SERVICE BULLETIN No.1106

COACH MODEL : C2045 with sliding lift door

BULLETIN TYPE: Field Change Program

SUBJECT : Lift door conversion

Figure 17: Emergency handle pull rod guide

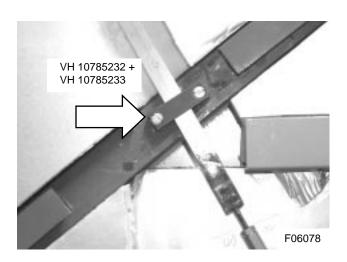
Tighten to a torque of 6 ft.lbf (8 Nm). Reinstall the emergency handle for checking purposes.
- 9) Connect emergency handle pull rod VH 10781141 to lever VH 10779707 with a snap-on rod end, as shown in Figure 13.
- 10) Using base plate VH 10785232 as a template, mark and drill two mounting holes (diameter 4.25 mm) in the door frame. Tap with an M5 tap to accept flat head screws VH 660282101 (see Figure 17).
 - Install the base plate and guide VH 10785233. Make sure that there is no binding of the rod and that it can move freely. Tighten the screws to a torque of 6 ft.lbf (8 Nm).

Figure 19: The three critical positions of the door lock paddle operation

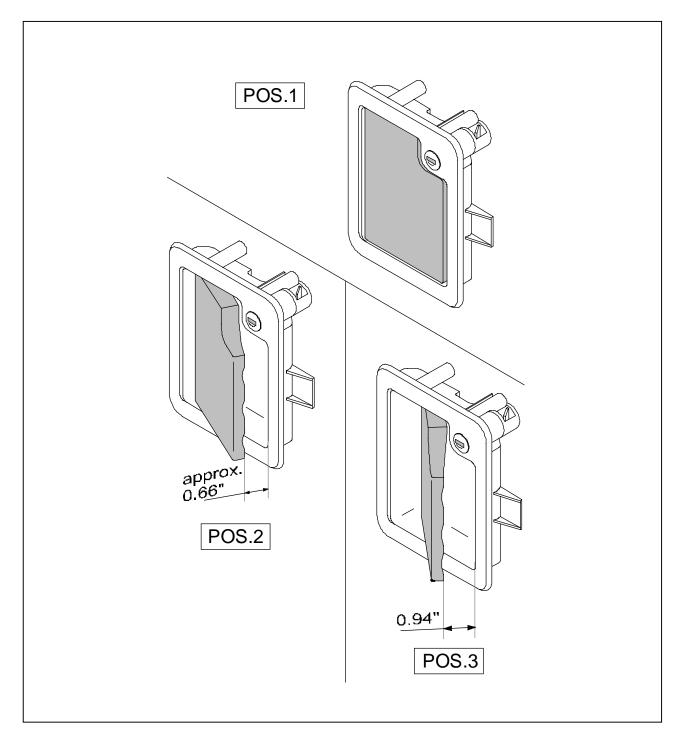
- 1) Adjust rod VH 10765453 so that it is possible to easily slip your fingers behind the paddle of the door lock, without any of the rotary latches unlocking (position 2, Figure 19). The bottom latch should open between position two of the paddle and the full stop position (position 3, Figure 19), ie when the paddle butts against the door lock housing. Secure the turnbuckle with the jam nuts.

- Adjust the length of push/pull rod VH 10781482 so that the upper rotary latch opens BEFORE the lower one when the door lock paddle is being pulled. The lower rotary latch should unlock last. Secure the turnbuckle with the jam nuts when adjustment has been completed.

- 3) Adjust the length of emergency handle pull rod VH 10781141 so that, with the emergency handle pointing down, the pivot pin on the cam rests against the lower part of the slot. Secure the turnbuckle with the jam nuts when adjustment has been completed.

The linkage conversion is now completed. Check the operation of the door lock mechanism with the door locked from the outside. It should be possible to open the rotary latch assemblies using the emergency handle. Operate the linkage very slowly and check that the upper rotary latch assembly releases first.

Figure 22: Machine screw retaining channel glued to insulation panel VH 10785621

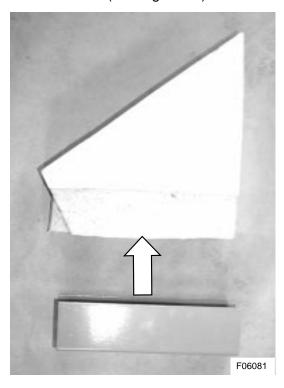
1) Glue self-tapping screw retaining channel VH 10785570 to insulation panel VH 10785621 with Sika Tack (see Figure 22). Allow adhesive to cure.

Figure 25: Trim closing panel installation

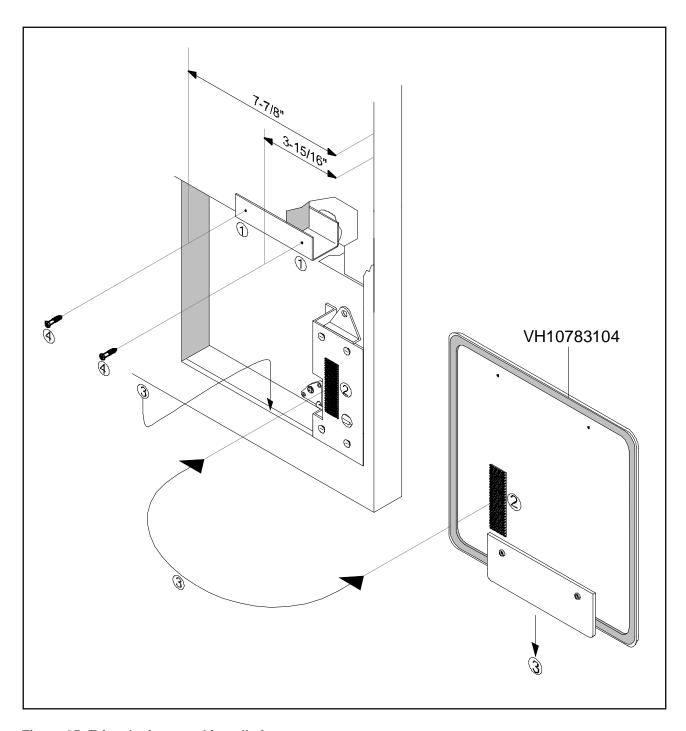
- 2) Install the main trim panel in reverse order to removal, using the salvaged self-tapping screws to secure the panel.
- 3) Trial fit the closing panel (see Figure 25). The right hand edge should be approximately 25/32 inch (20 mm) from the doorpost. The bottom edge of the panel should be approximately 2-11/64 from the bottom edge of the door. Referring to the dimensions in Figure 26, drill two holes in the panel and the U-channel behind it to suit the recovered self-tapping screws (1, Figure 25).

- 4) Remove the closing panel and install Velcro strips on the door lock housing and the back of the panel (2, Figure 25).
- 5) Reinstall the cover panel (3, Figure 25) and secure with the self-tapping screws (see 4, Figure 25).

Figure 27: Sliding lift door drain holes

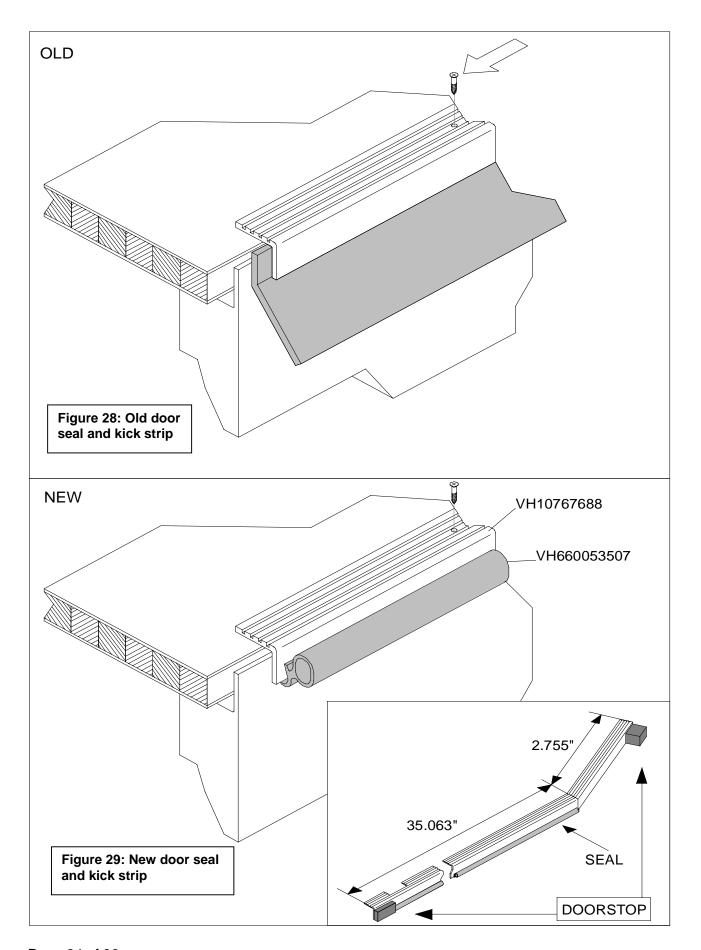
- 1) Add three 1/8 inch (3 mm) holes in the bottom channel of the sliding door as shown in Figure 27.
- 2) Coat the holes with zinc primer.

Figure 43: Parallel opening door adjustment references

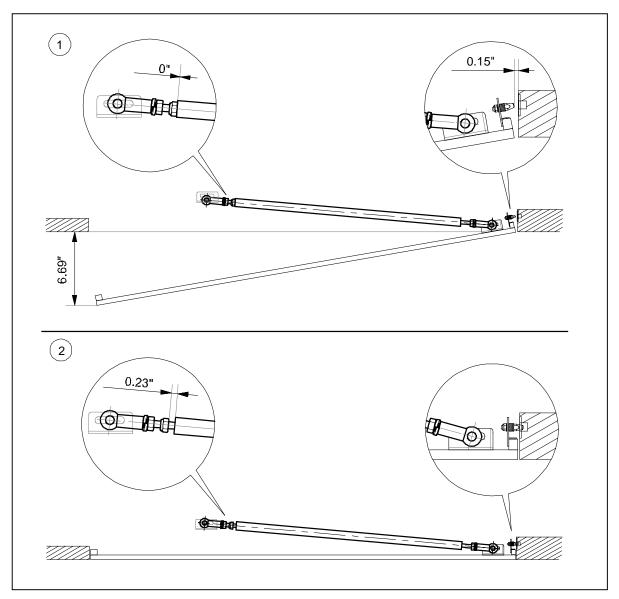
3) Undo the chassis to door tie rod ball joint nuts. Adjust the springloaded tie rod referring to Figures 43.1 and 43.2 on page 31.

Figure 43.1 shows the door slightly open on one side with the guide pins close to the catches. The tie rod body to jam nut clearance should be 0 inch. Figure 43.2 shows the door fully closed. The tie rod body to jam nut clearance should be 0.23 inch with the guide pins fully seated.

Figure 47: New shape of roller arm VH 10793025

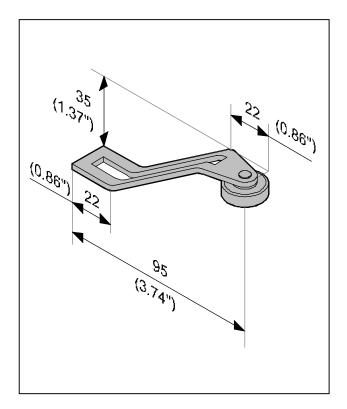
- 4) Undo the Allen bolt securing the roller arm clamp to the shaft of the switch. Remove the roller arm assembly.
- 5) Remove the roller arm from the clamp by unscrewing and removing the Allen bolt and clamping plate. Note the position of the clamping plate. Discard the old roller arm.
- 6) New arm VH 10793025 replaces the old, straight arm (see the dimensions in Figure 47 as a reference).

Figure 48: New switch installation dimensions (in mm and inches)

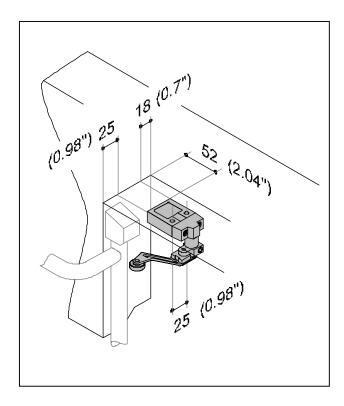
- 7) Assemble the new roller arm with the clamping plate and clamp, and adjust the arm to full length. Tighten the Allen bolt to a torque of 30 in.lbf (3.5 Nm).
- 8) With a scribe, mark the position of the new switch mounting holes on the upper lift compartment channel. Refer to Figure 48 for the correct dimensions.

- 9) Drill two holes suitable for M5x0.8 threaded inserts. Install the inserts. Secure the switch to the upper channel with two M5x0.8x25 mm bolts. Tightening torque 6 ft.lbf (8 Nm).
- 10) Stow away excess switch wiring with tie wraps.
- 11) Install the roller arm assembly on the shaft with the wheel pointing down. The arm should be biased some 30° towards the front of the coach (see Figure 49). Tighten the Allen bolt to a torque of 30 in.lbf (3.5 Nm).
